Access Compliance Report

Public Rights-of-Way

(Curb Ramps)

Intersection ID: 52716	Main Street: AGAVA_LN	Cross Street: MAIDENHAIR_CT	Location: W
ADA ID: 1950C0428235	Ramp Type: Perp	Initial Pass/Fail: Pass	Overall Compliance: No
Severity Score: 0			
Codes/Mitigation Info/Possible Solution		Field Measurements/Component Compliance

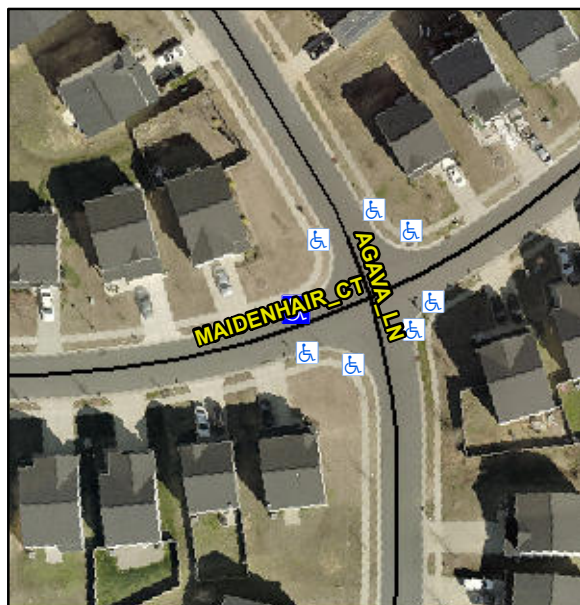
Surveyor Notes:

N/A

Not Found, R302.7

Possible Solutions:

Remove & Replace Entire Ramp.
